**Addendum No. 2  
January 19, 2024**

Project: **Lennox High School Addition**  
Lennox, South Dakota  
Architecture Incorporated Project No.: 2982

Architect: Architecture Incorporated

1  
4.40 FLOOR PLAN AREA E - LOCKER ROOMS  
SCALE: 1/4" = 1'-0"

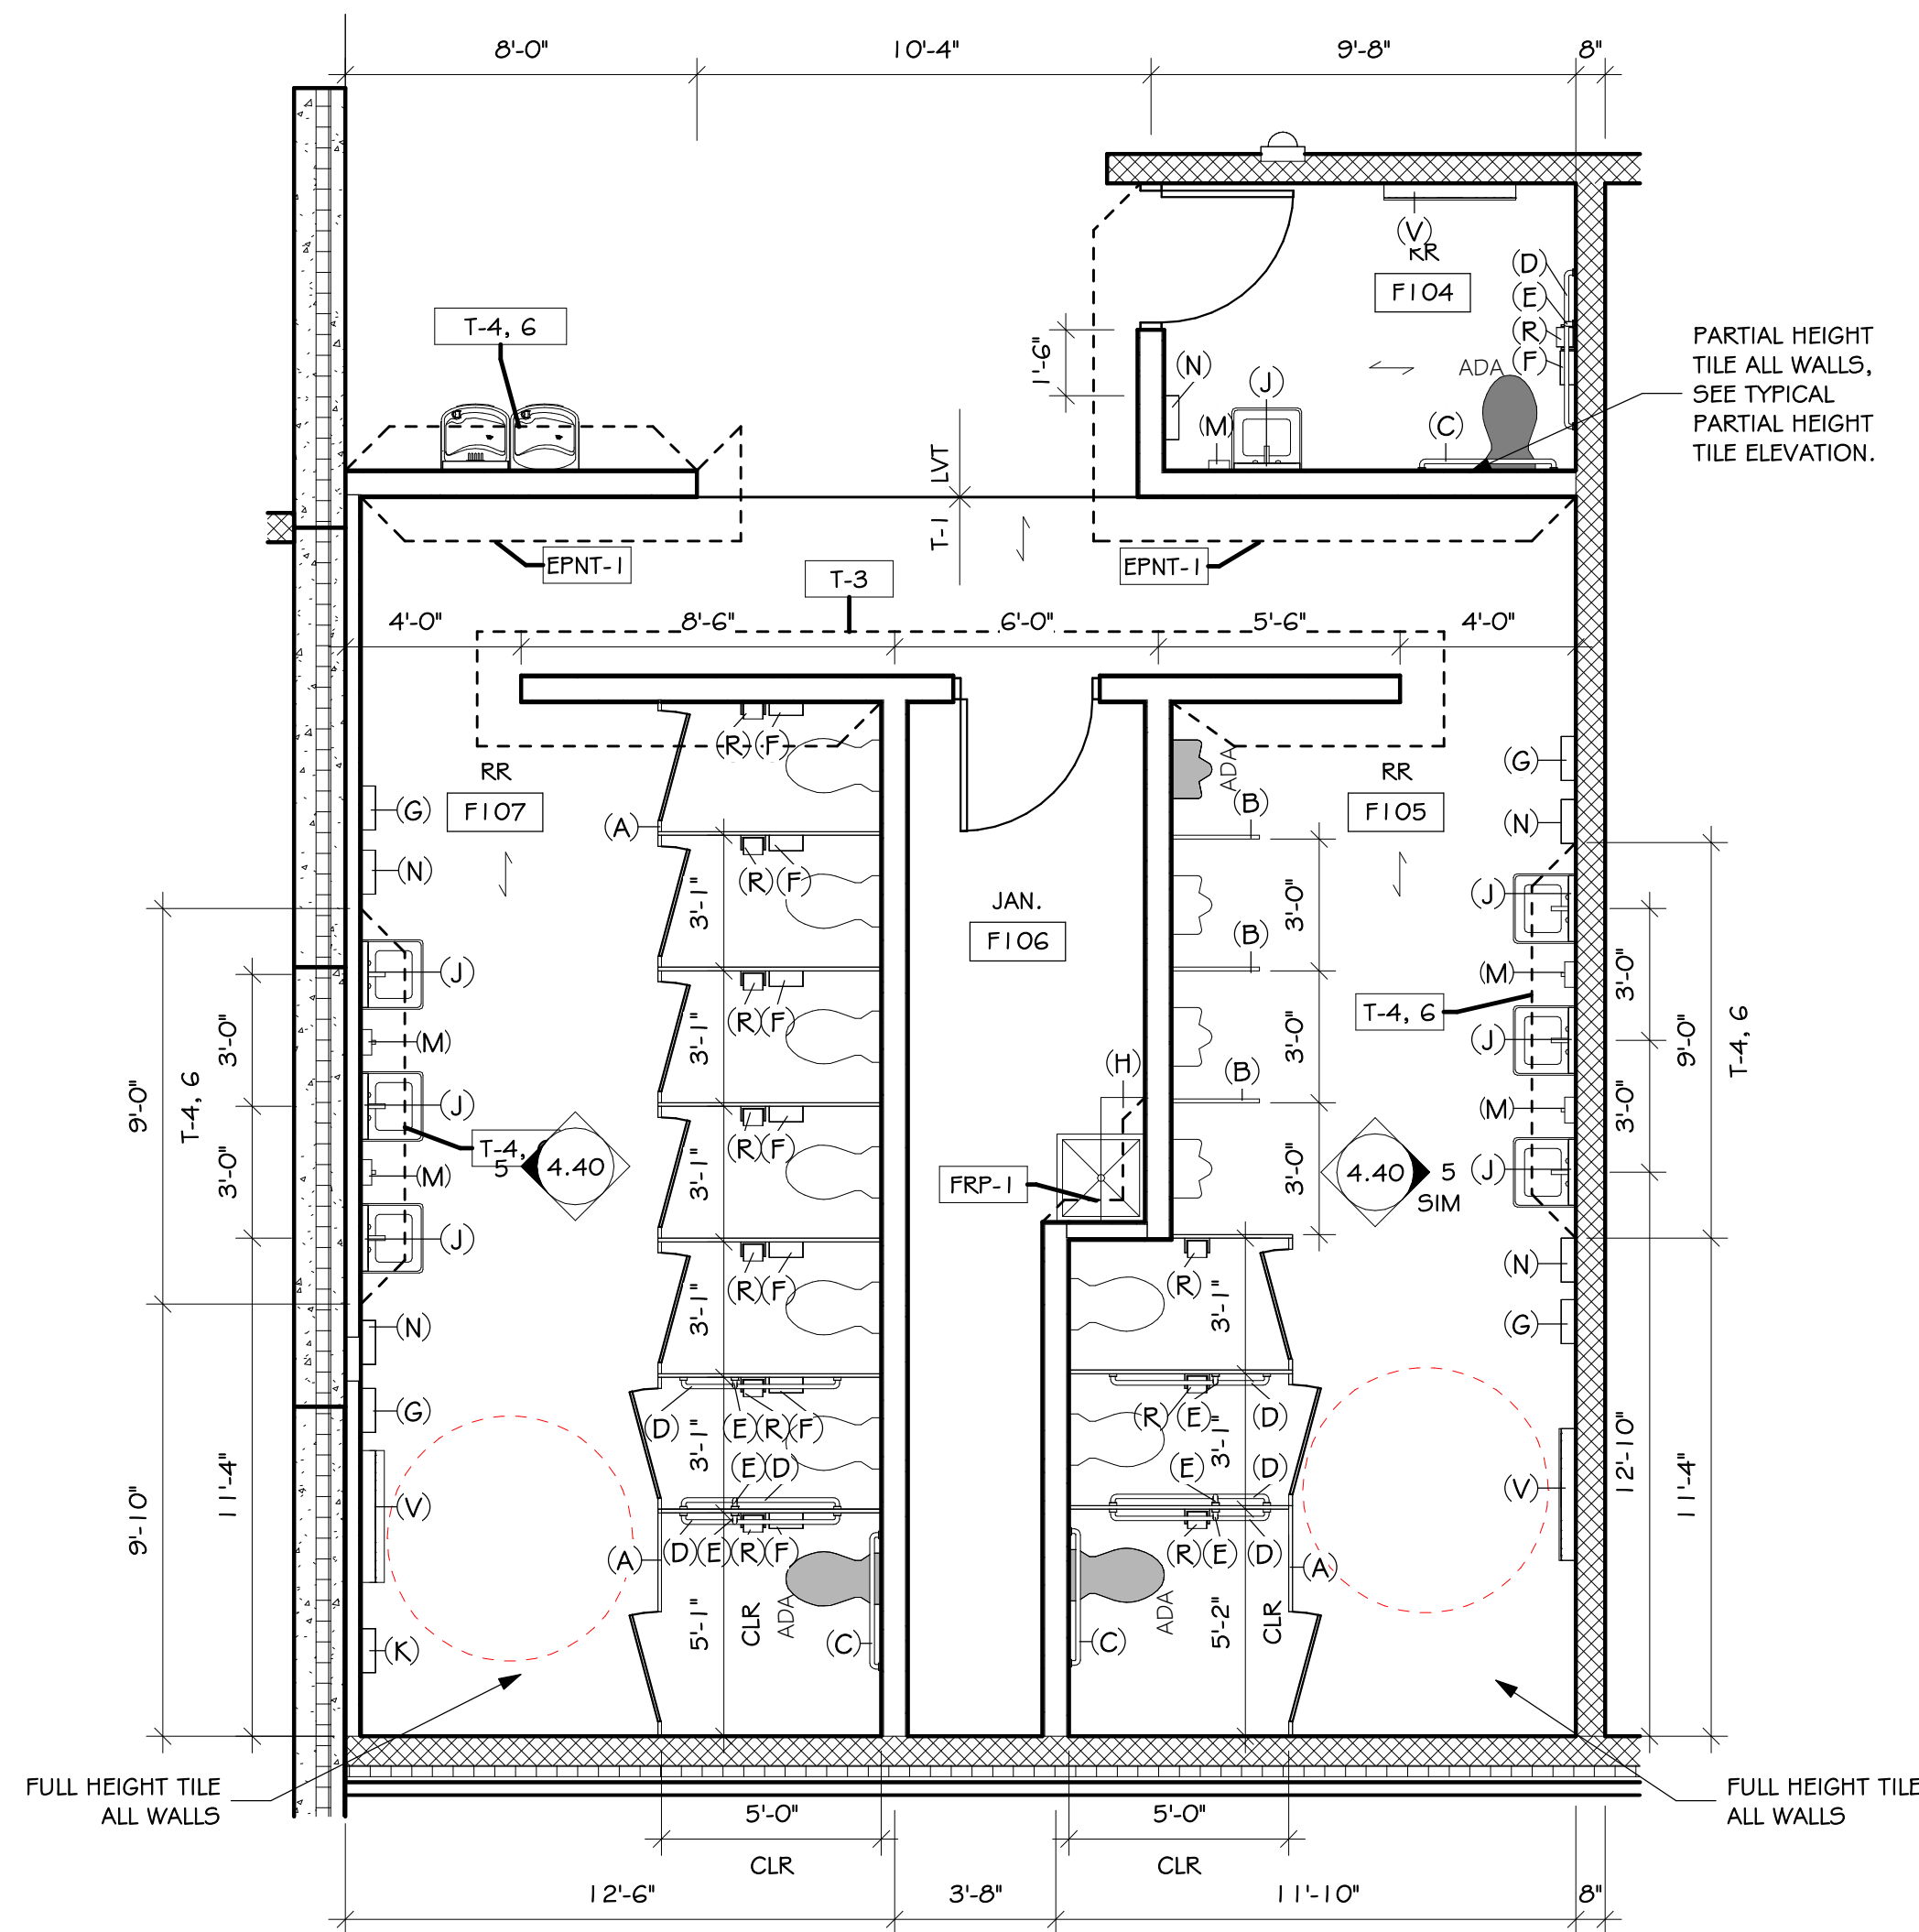
26) SHEET 4.40- ENLARGED PLANS – RESTROOM, LOCKER ROOM & CONCESSIONS

- a) Reference *revised* drawing Sheet 4.40, dated 1-18-24, attached to the end of this addendum for the following:
  - i. The Contractor shall include furnishing and installing metal trim / filler panels and sloped locker tops where the lockers form inside corners. Reference the NW & SW corners of Locker E115 and the NE & SE corners of Locker E108.
  - ii. The Contractor shall include furnishing and installing metal trim / filler panels and sloped locker tops where the lockers abut CMU walls in Locker E115 and Locker E108, as indicated per revised drawing Sheet 4.40.
  - iii. Provide an additional 16” of CMU wall at the entrance to Locker E115 to prevent line of sight issues as indicated per revised drawing Sheet 4.40.
  - iv. Provide an additional 16” of CMU wall at the entrance to Locker E108 to prevent line of sight issues as indicated per revised drawing Sheet 4.40.
